SN J1981B-06

<u>SERVICE NOTE</u>

J1981B Telegra VQT

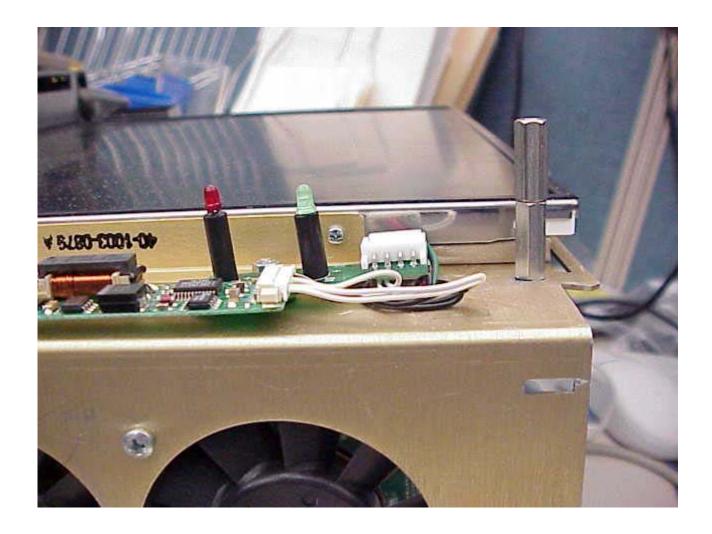
When the front bezel is removed from these units it is possible to damage the LED's. In order to preclude this damage an aluminum standoff is required to be inserted through the front panel sheet metal and fastened on the internal surface of the sheet metal. Please see the accompanying pictures.

When the front bezel is removed, a hole in the sheet-metal is exposed. It is through this hole that the stand-off should be mounted. See second photo.

Remove stand-off prior to replacing front bezel.
